# Drainage Report

## LA CUENTISTA SUBDIVISION – Unit III

A Supplement to the  
Drainage Report for La Cuentista Subdivision  
Dated November 2003

**Re: La Cuentista Unit III Drainage Report and Grading Plan  
Engineer's Stamp dated 4-18-08 (D10/D002A)**

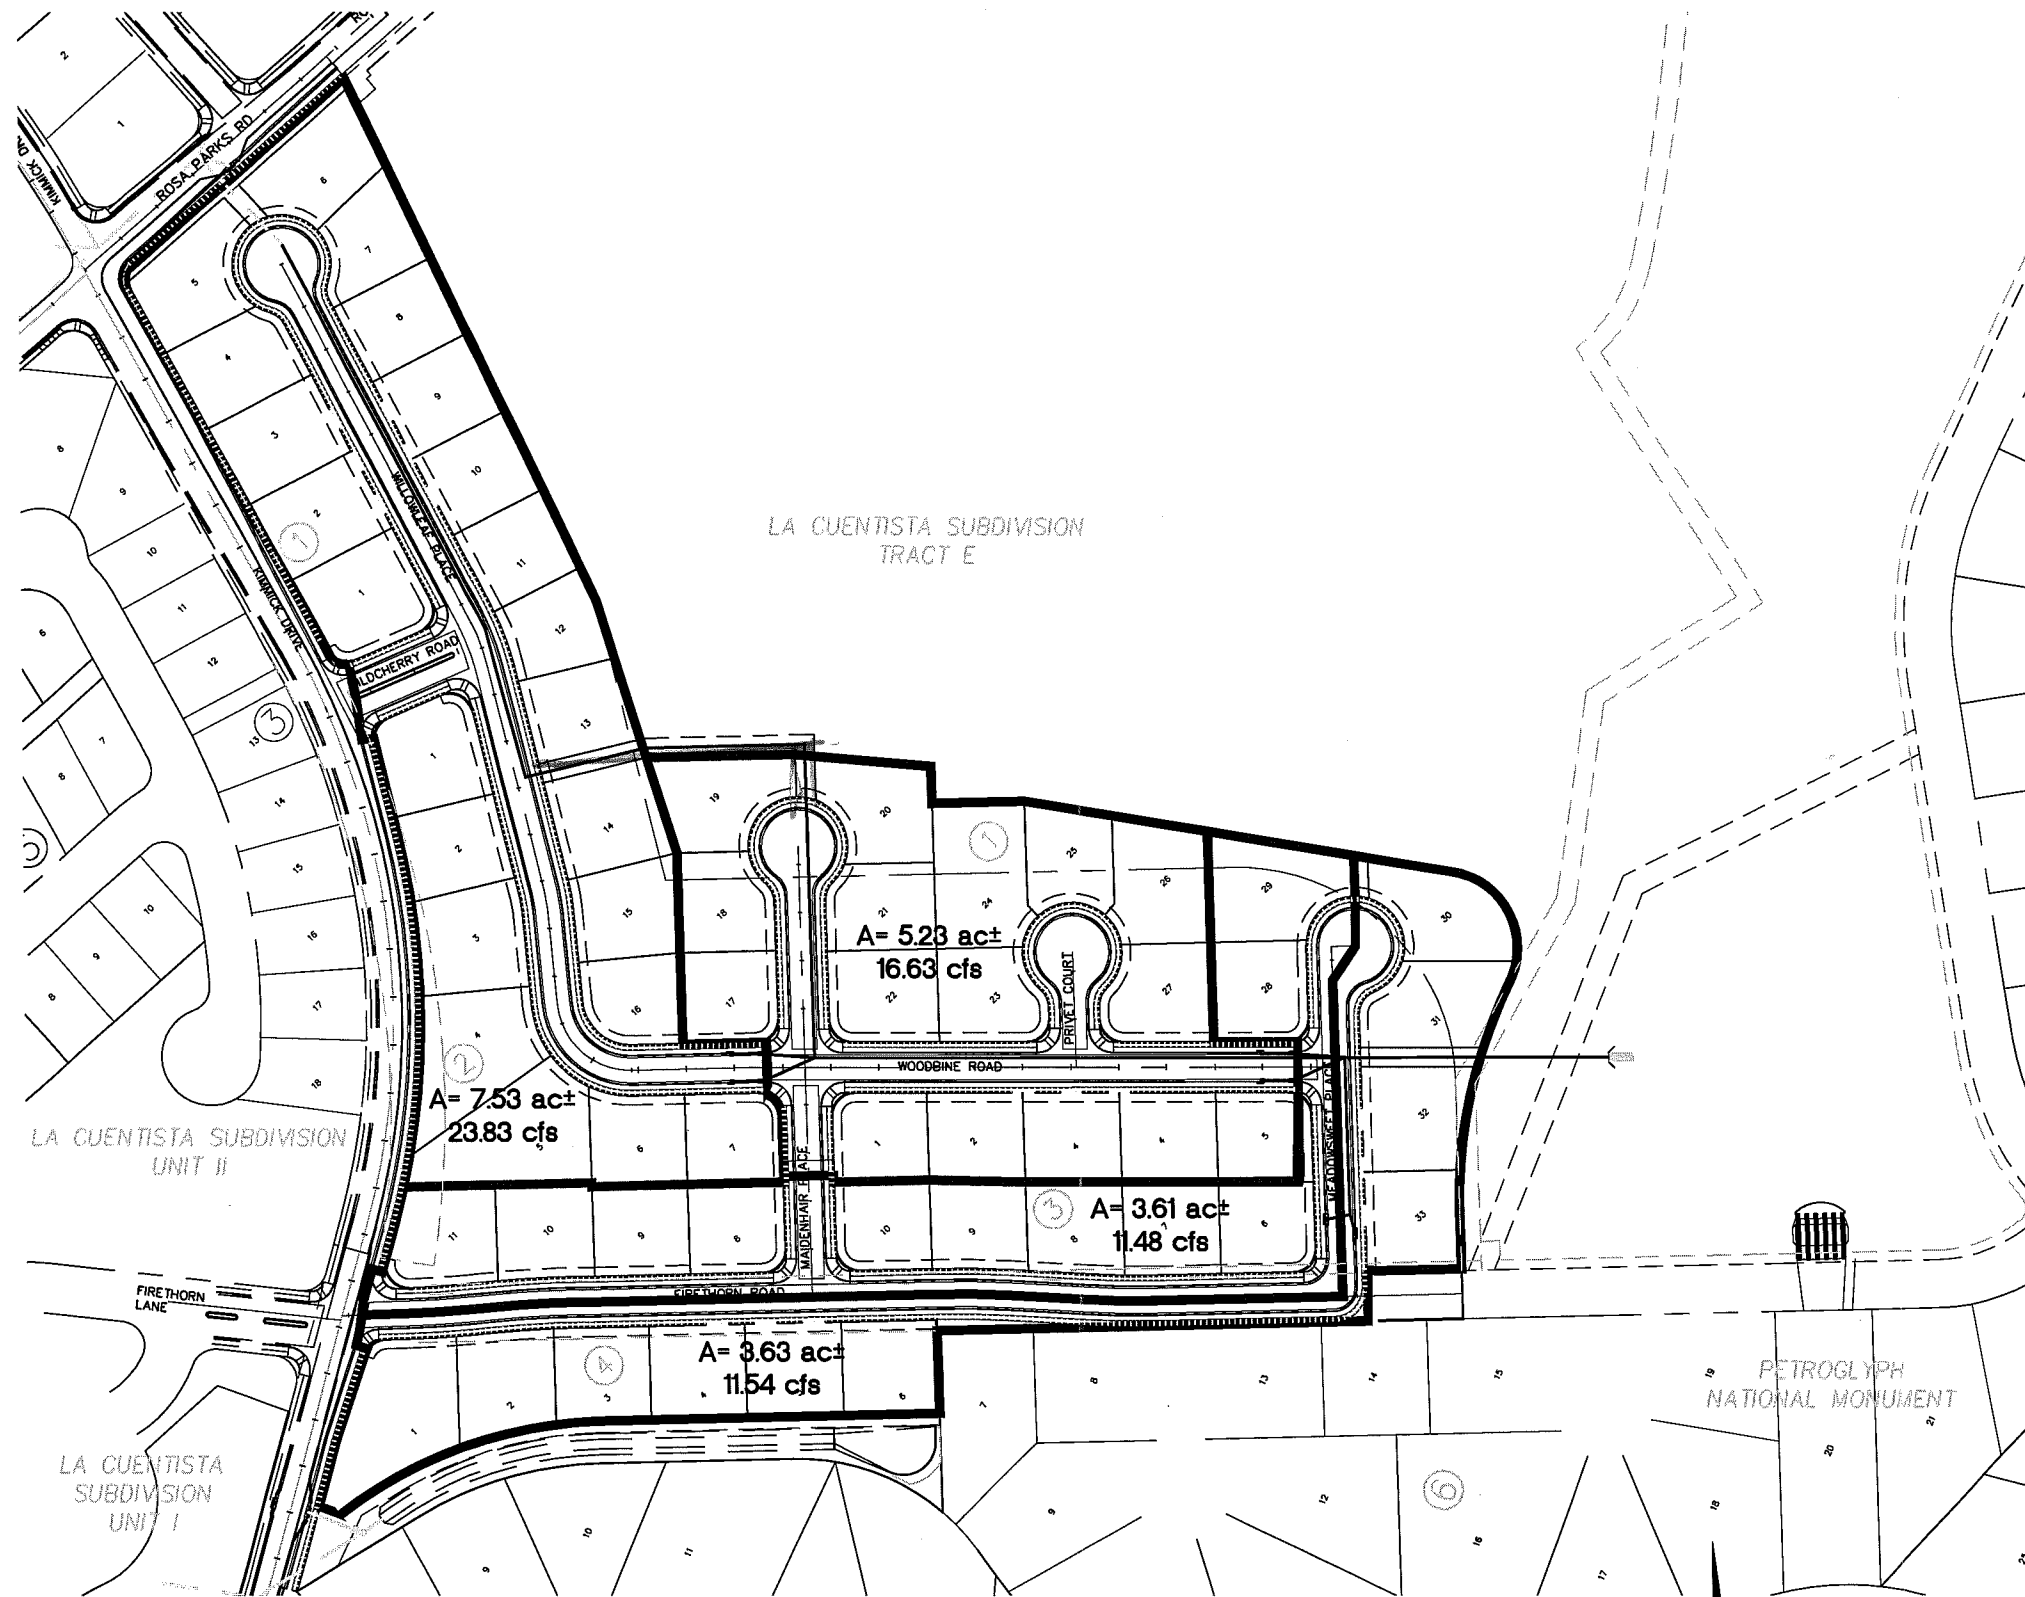
Inlets are required on Willowleaf PL to prevent runoff from leaving the street where Willowleaf PL meets Woodbine Rd.
